SUBJECT: **NEW VEHICLE DEMONSTRATION / DELIVERY HOLD**
Compliance Recall 23C35 – Supplement #1
Certain 2020-2023 Model Year Mustang
Body Control Module (BCM) Software Configuration

Compliance Recall 23C35 – *Supplement #1*

CERTAIN 2020-2023 MODEL YEAR MUSTANG VEHICLES — BODY CONTROL MODULE (BCM) SOFTWARE CONFIGURATION

FIGURE 1

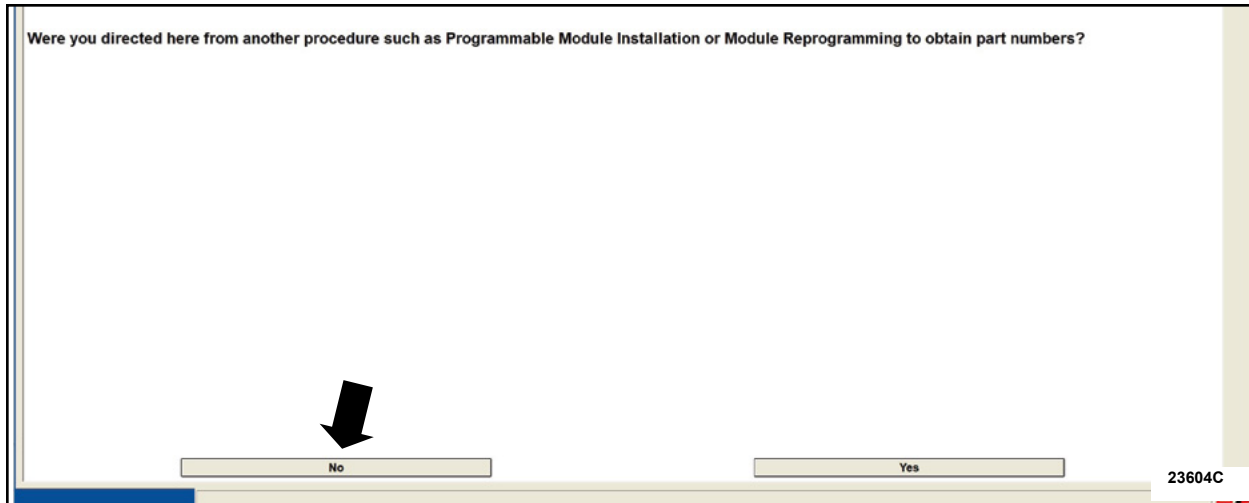
3. When asked if you were directed here from another procedure such as Programmable Module Installation or Module Reprogramming to obtain part numbers, select **No**. See Figure 1.

FIGURE 2

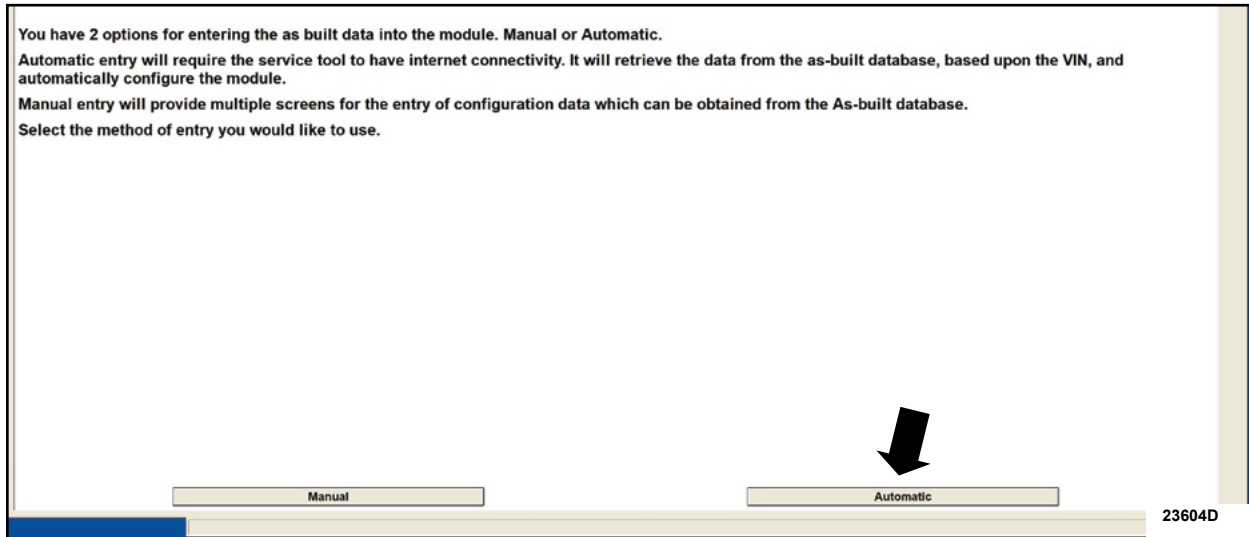
4. When asked which option to enter the as built data into the module, select **Automatic**. See Figure 2.
